SITE AUDIT REPORT

10 Nelson Short Street, Potts Hill NSW 2143

Mushan Group Pty Ltd

18140 SAR KJL196 SctB

Figure 3: Proposed Borehole Location Plan

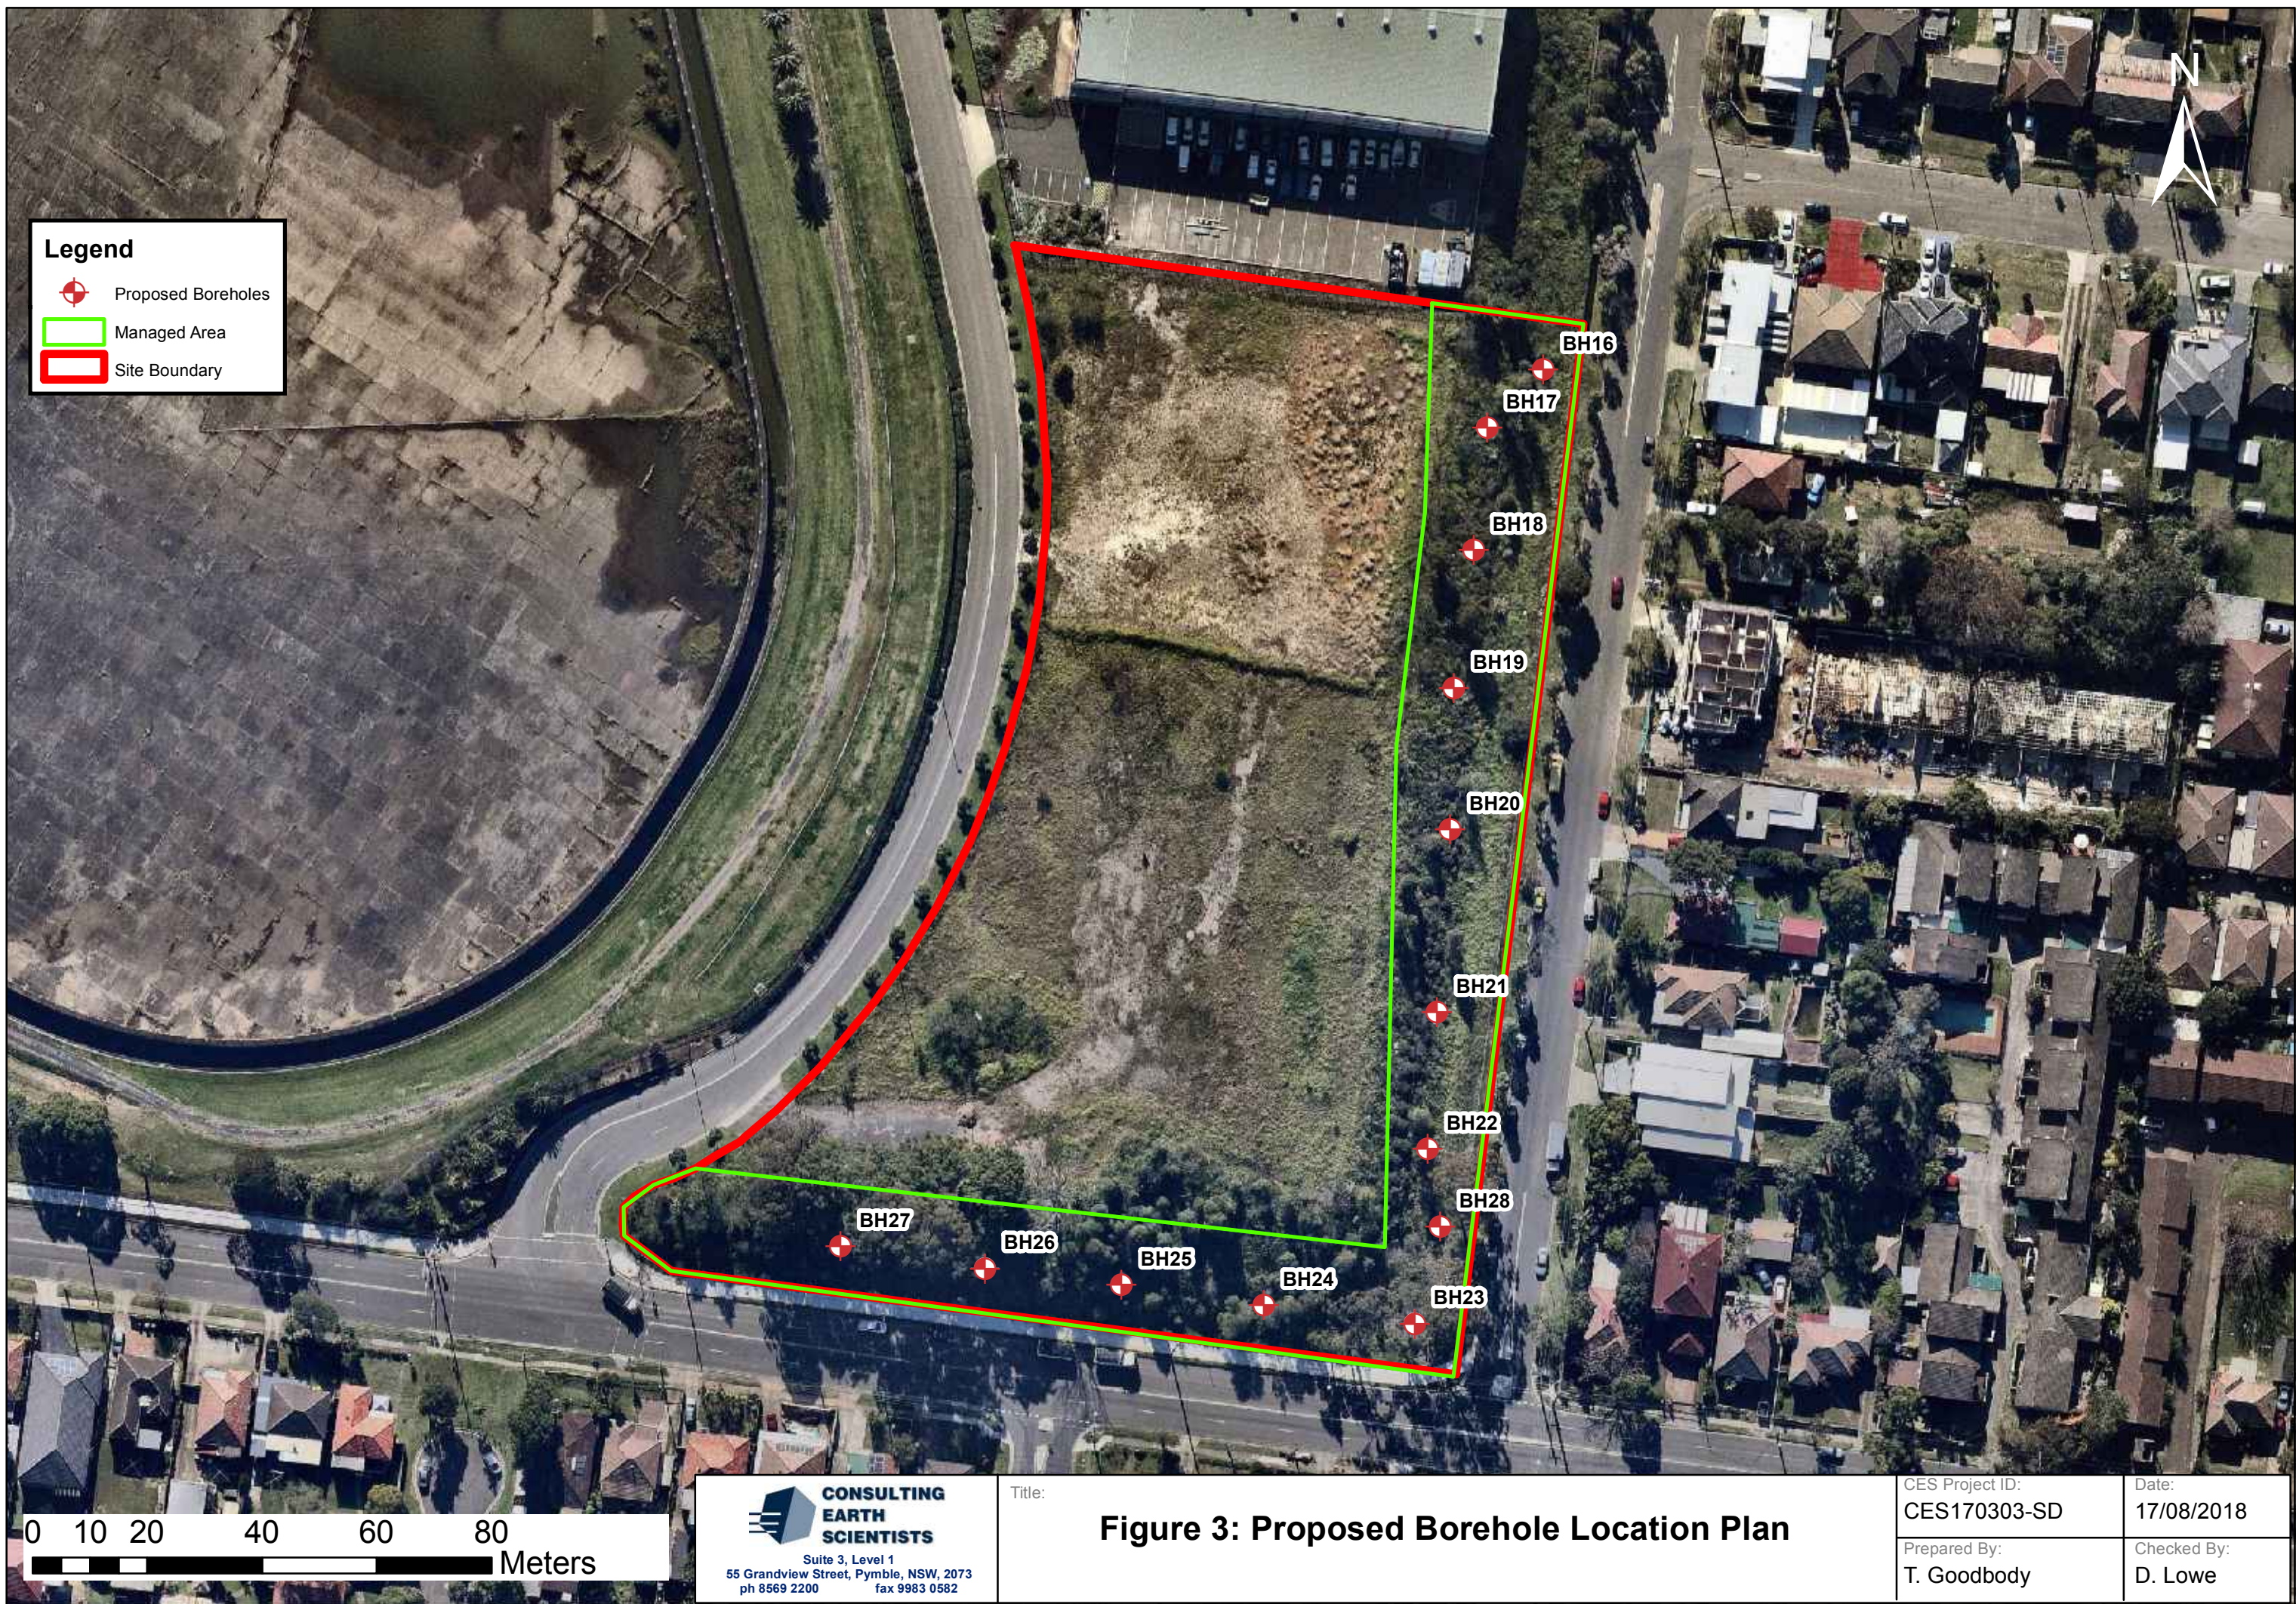
28	Figure 3: It would appear that most of the sampling locations for the embankment area (BH16 to BH28) are located within the “embankment” and not “apron”. Given previous audit states that only limited samples had been collected within the “apron”, please consider conducting some samples within the “apron” area.	Two sample points have been relocated to target the ‘apron’ area of the site.	Figure 3
